The Clairemont Community Plan Update (CCPU)

The Clairemont Community Plan Update (CCPU)

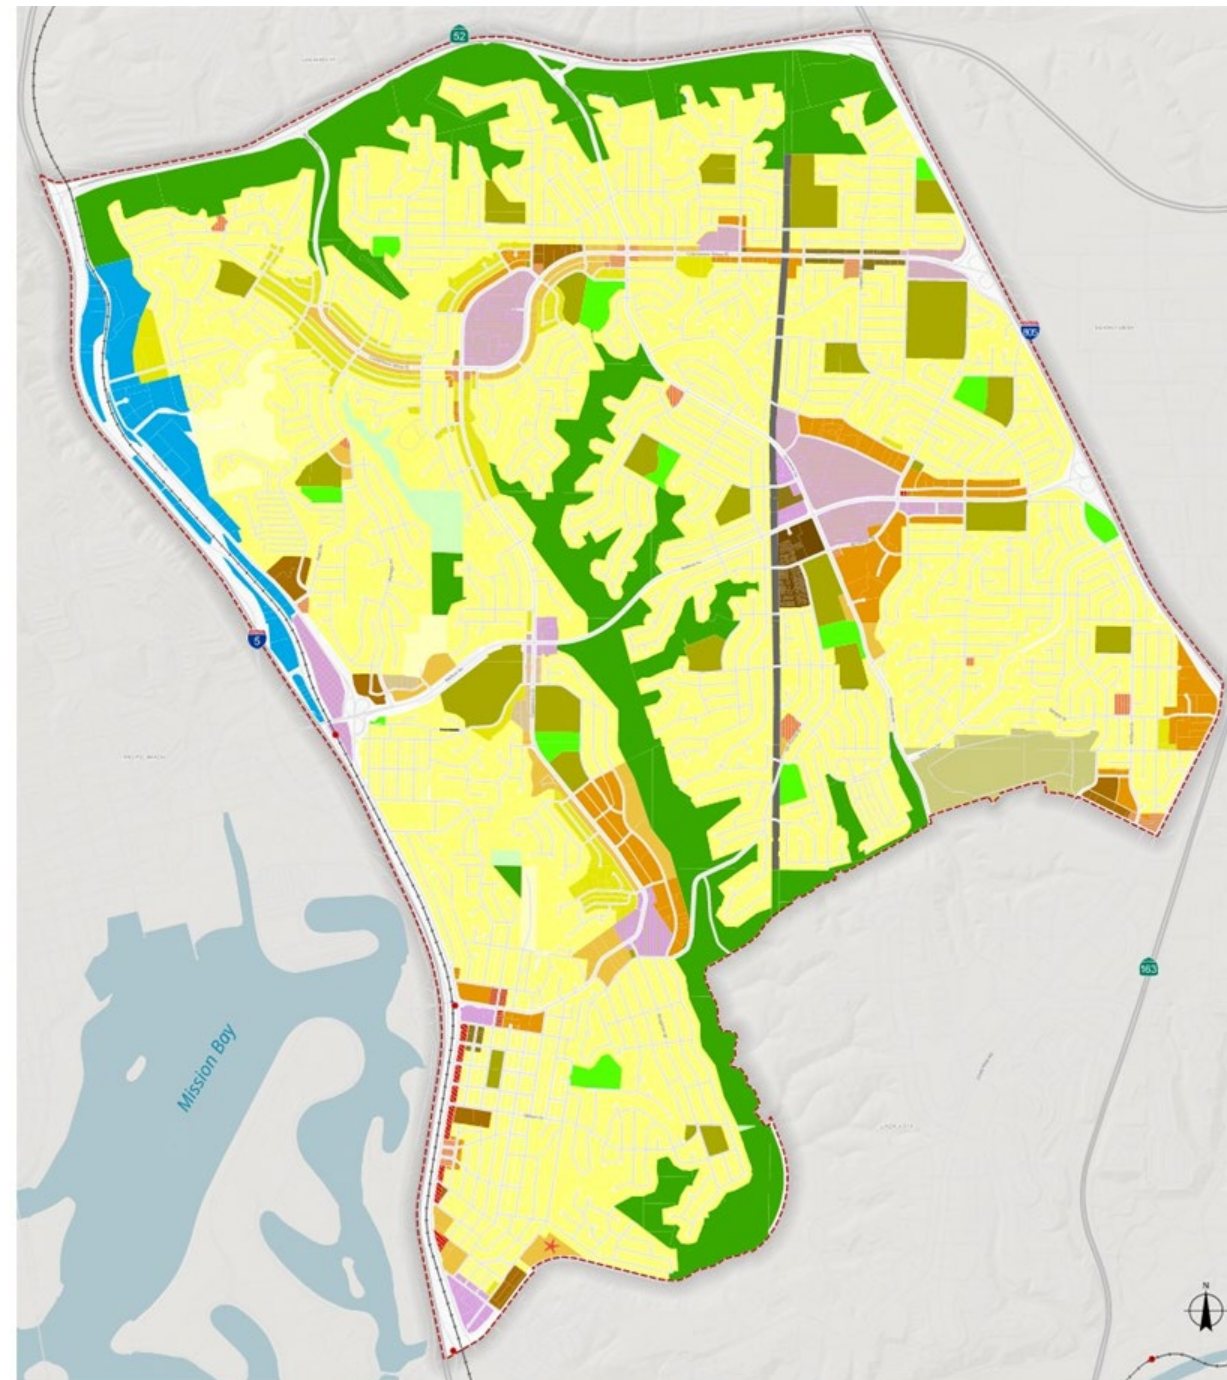
One question we have is that canyonland protection is a stated goal in the CCPU, but only a small portion of the private canyons are recognized as “Open Space”, see the two areas highlighted in red at right.

Clairemont, a community of Mesas and Canyons

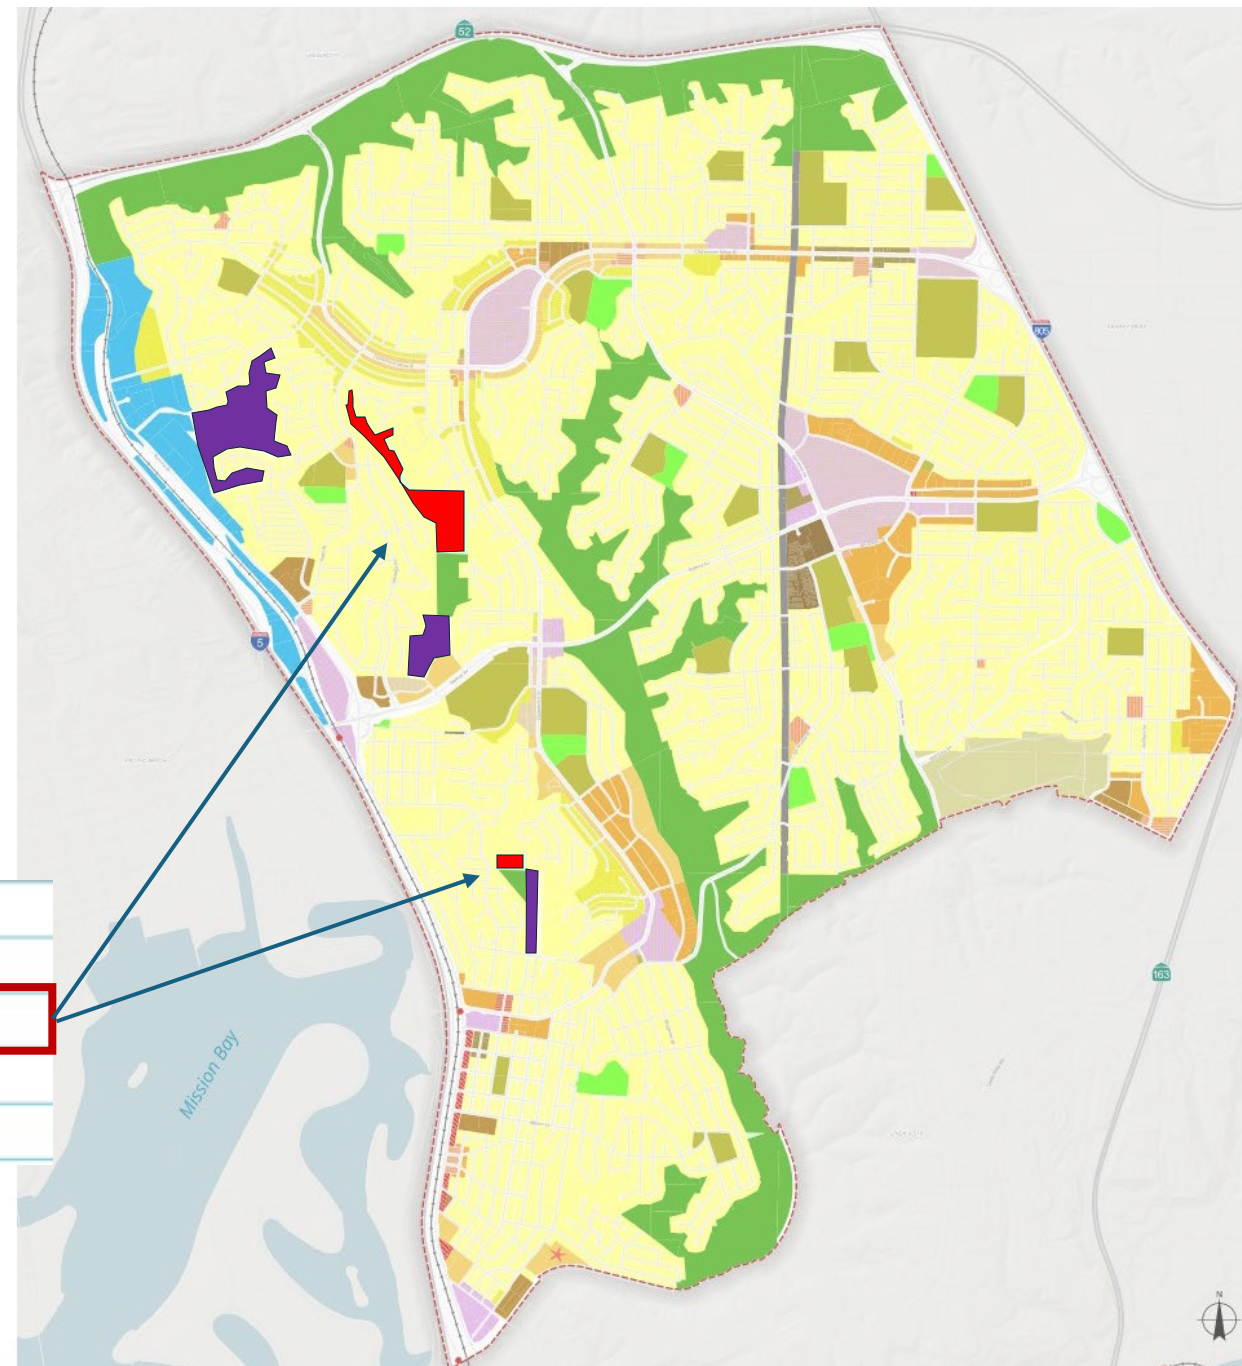
Clairemont includes hundreds of acres of private canyons that provide significant quality of life and environmental benefits. Most of these private canyons are not recognized as the open space they are, see canyons highlighted in yellow at right.

In a similar way to the Open Space designation, are there mechanisms within the plan to add additional protection to the important private open space canyonlands in Clairemont?
